Administrative Action Administrative Site Review

Case File / Name: SR-82-16, 1600 Cross Link Road

Request: Development of a 1.24 acre tract zoned CX-3-PL into a 9000 square foot, 20' 6" retail building.

SR-82-16 Preliminary Site Plan

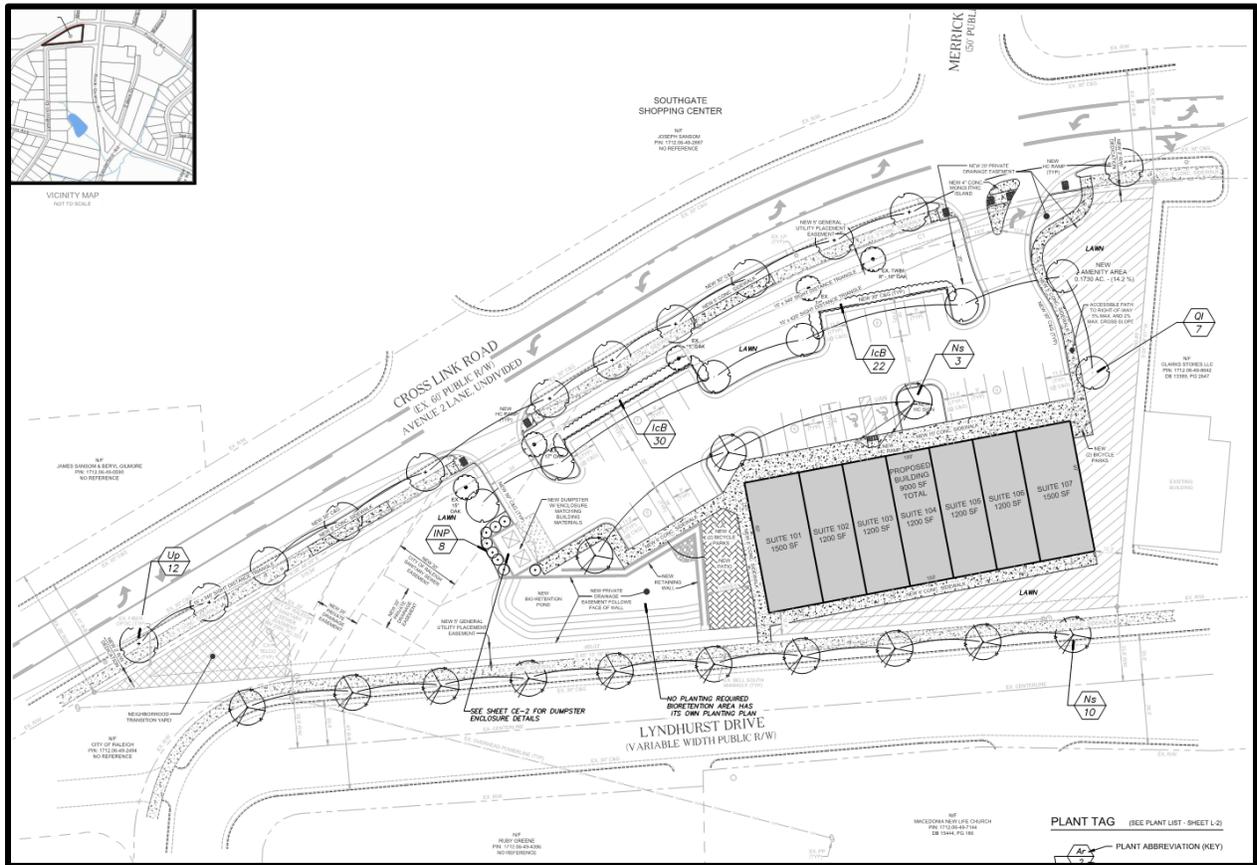
Administrative Alternate Findings:

1. The approved alternate meets the intent of the build-to regulations;
Staff response: The project contains a building located within the range of building placement and building width that supplements the existing street edge along Cross Link Road. The alternate provides flexibility for specific site design along Cross Link Road, allowing the building to meet the Build-to regulations along the longest property edge of an irregularly-shaped lot.

2. The approved alternate conforms with the Comprehensive Plan and adopted City plans;
Staff response: The project conforms to several Comprehensive Plan policies, including LU 5.1, LU 7.4, T 5.10, and T 6.8.

3. The approved alternate does not substantially negatively alter the character defining street wall or establish a build-to pattern that is not harmonious with the existing built context;
Staff response: The project does not negatively alter the character defining streetwall or establish a development pattern that is not harmonious with the existing built context. The scale and design of the proposed building is similar to and reinforces the pattern of surrounding development along Cross Link Road.

4. The change in percentage of building that occupies the build-to area or increased setback does not negatively impact pedestrian access, comfort or safety; and
Staff response: Pedestrian access is still maintained along Cross Link Road, and from the sidewalk on Cross Link Road to the proposed building within the development. The pedestrian access way from Cross Link Road also provides access to the amenity area proposed along Cross Link Road. A pedestrian access from the building to the sidewalk along Lyndhurst Drive to the south is also provided.

5. Site area that would have otherwise been occupied by buildings is converted to an outdoor amenity area under Sec. 1.5.3.B.
Staff response: The applicant is providing amenity areas in two locations that fall within the 100 foot Build-to range, one at the eastern edge of the property adjacent to Cross Link Road and the other directly adjacent to the western edge of the proposed building. Both will contain seating options.

OFFICIAL ACTION: Approval with conditions

Decision The Planning and Development Director finds that the requested alternate generally meets the findings enumerated in the Unified Development Ordinance
